Project	IEEE 802.16 Broadband Wireless Access Working Group < http://ieee802.org/16 >	
Title	Proposed Text of Base Station and Relay Station Frame Structure for the IEEE 802.16m Amendment	
Date Submitted	2008-11-03	
Source(s)	Kanchei (Ken) Loa, Yi-Hsueh Tsai, Chun-Yen Hsu, Youn-Tai Lee, Chih-Wei Su, Yi-Ting Lin, Tsung-Yu Tsai, Chiu-Wen Chen, Jiun-Je Jian Institute for Information Industry (III) Yung-Ting Lee, Hua-Chiang Yin Coiler Shiann-Tsong Sheu National Central University (NCU)	Voice: +886-2-66000100 Fax: +886-2-66061007 loa@iii.org.tw , lucas@iii.org.tw
Re:	IEEE 802.16m-08/042 "Call for Contributions on Project 802.16m Draft Amendment Content"	
Abstract	Proposed Text of Base Station and Relay Station Frame Structure for the IEEE 802.16m Amendment	
Purpose	We propose 16m base station and relay station frame structure	
Notice	<i>This document does not represent the agreed views of the IEEE 802.16 Working Group or any of its subgroups. It represents only the views of the participants listed in the "Source(s)" field above. It is offered as a basis for discussion. It is not binding on the contributor(s), who reserve(s) the right to add, amend or withdraw material contained herein.<

Figure 308a Basic frame structure

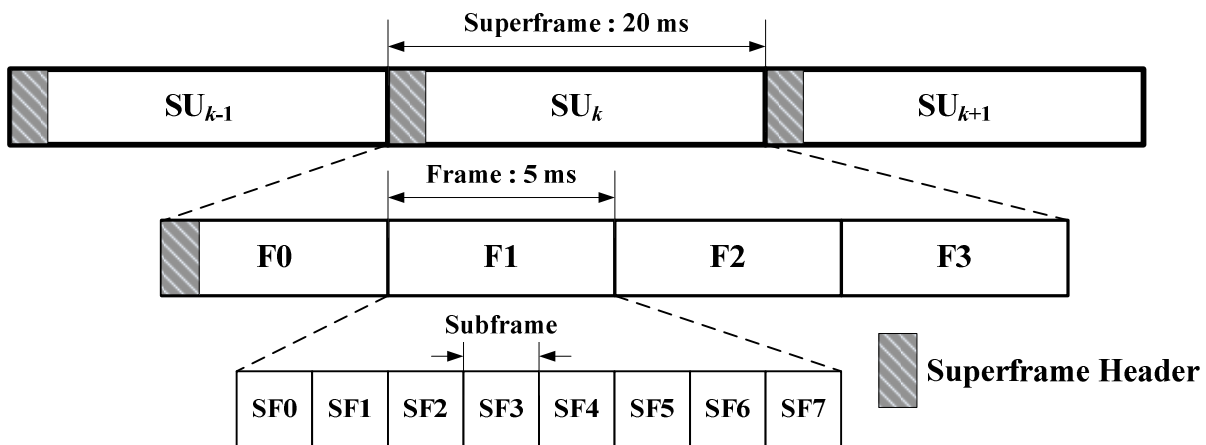
The basic frame structure, illustrated in Figure 308a, shall be applied to FDD and TDD duplexing schemes, including H-FDD MS operation. Each 20 ms superframe shall be divided into four 5 ms frames. Each frame shall consist of eight subframes when using the OFDMA parameters defined in Table xxx with the channel bandwidth of 5 MHz, 10 MHz, or 20 MHz. Each subframe shall be assigned for either DL or UL transmission.

Figure 308b BS Frame structure in TDD mode (CP of 1/8 useful OFDM symbol time and DL to UL ratio of 5:3)

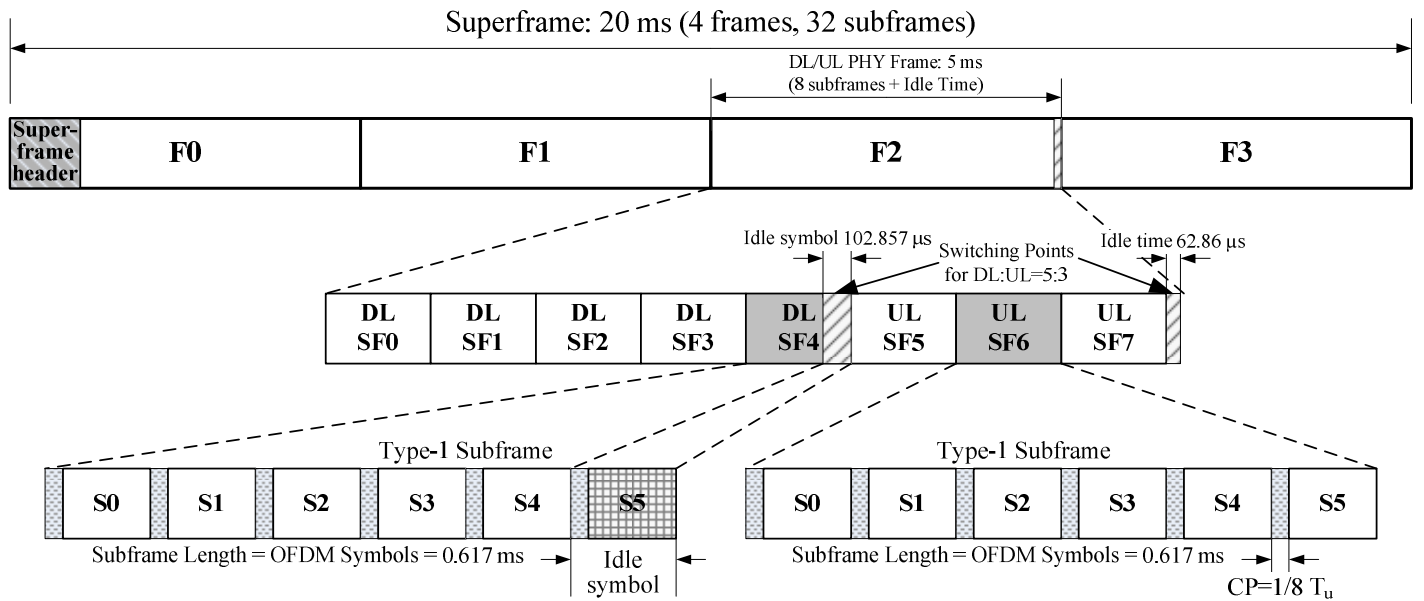
In TDD systems, the number of switching points in each radio frame is either two or four. Figure 308b illustrates an example of BS frame structure with a DL to UL ratio of 5:3, where OFDM symbol duration is $102.857\mu\text{s}$, CP length is 1/8 useful OFDM symbol time, and the length of type-1 subframe is 0.617 ms. The last DL subframe, i.e., DL SF4, is a type-1 subframe whose last OFDM symbol is an idle symbol to accommodate the gap required to switch from DL to UL. Figure 308c illustrates an example of BS frame structure with a DL to UL ratio of 5:3, where OFDM symbol duration is $97.143\mu\text{s}$, CP length is 1/16 useful OFDM symbol time, and the lengths of type-1 and type-2 subframes are 0.583 ms and 0.680 ms respectively.

Figure 308d TTR RS Frame Structure in TTR TDD mode (CP of 1/8 useful OFDM symbol time and DL to UL ratio of 3)

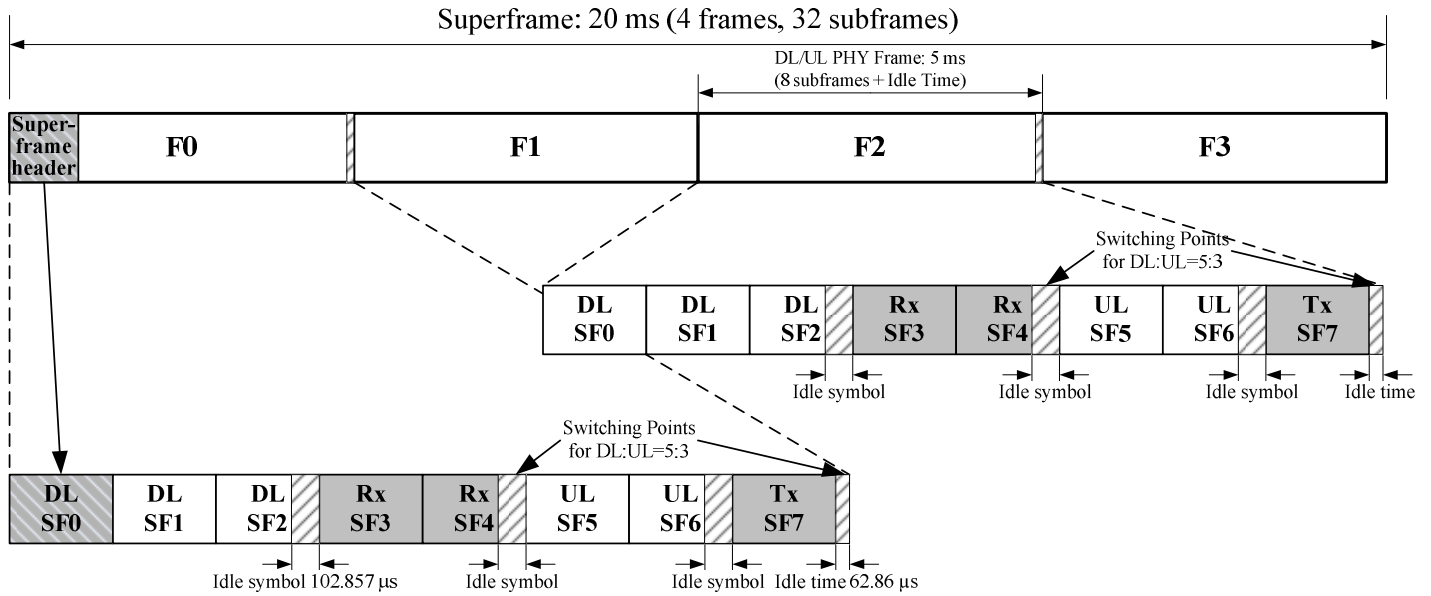
For the 2-hop relay system, the TTR RS frame may include DL subframes, or receive subframes, or UL subframes, or transmit subframes. The BS shall not schedule any traffic for the RS except the uplink-only RS in the first DL subframe of the first frame of the superframe since it contains broadcasting management messages, such as superframe header.

Two examples of TTR RS frame structure for 2-hop relay system with DL to UL ratio of 5:3 is illustrated in Figure 308d and Figure 308e, where OFDM symbol durations are 102.857 μ s and 97.143 μ s respectively, and CP lengths are 1/8 useful OFDM symbol time and 1/16 useful OFDM symbol time respectively.

Figure 308f BS frame structure in FDD mode (CP of 1/8 useful OFDM symbol time)

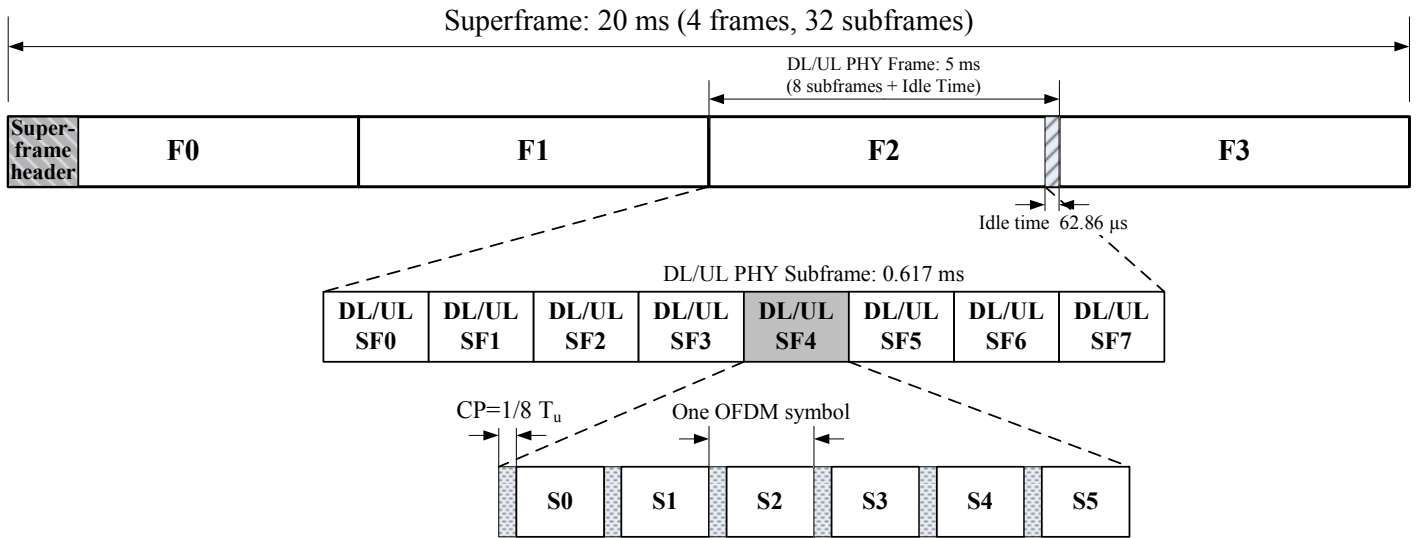
In an FDD system, when H-FDD mobile stations are included, the frame structure from the point of view of the H-FDD mobile station is similar to the TDD frame structure; however, the DL and UL transmissions occur in two separate frequency bands. The transmission gaps between DL and UL (and vice versa) are required to allow switching the TX and RX circuitry. Figure 308f shows an example of BS frame structure, where OFDM symbol duration is $102.857\mu\text{s}$, CP length is $1/8$ useful OFDM symbol time, and the length of type-1 subframe is 0.617 ms . Figure 308g illustrates an example of BS frame structure, where OFDM symbol duration is $97.143\mu\text{s}$, CP length is $1/16$ useful OFDM symbol time, and the lengths of type-1 and type-2 subframes are 0.583 ms and 0.680 ms respectively.

Figure 308h TTR RS Frame Structure in FDD mode

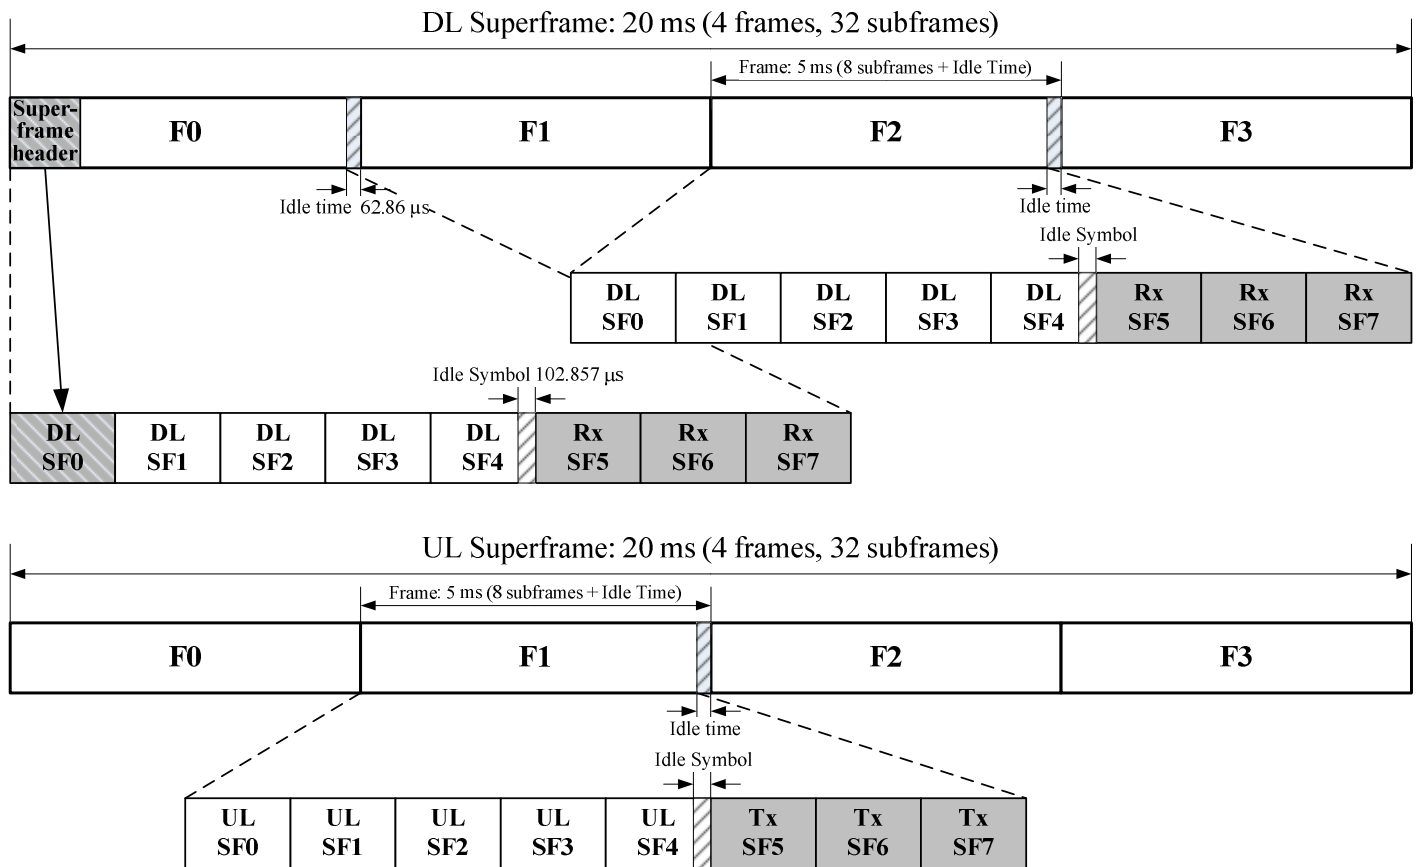
For the 2-hop relay system, the TTR RS DL frame may include DL subframes or receive subframes, and the TTR RS UL frame may include UL subframes or transmit subframes. The BS shall not schedule any traffic for the RS except the uplink-only RS in the first DL subframe of the first frame of the superframe since it contains broadcasting management messages, such as superframe header.

A examples of TTR RS frame structure for 2-hop relay system with DL to UL ratio of 5:3 is illustrated in Figure 308h.
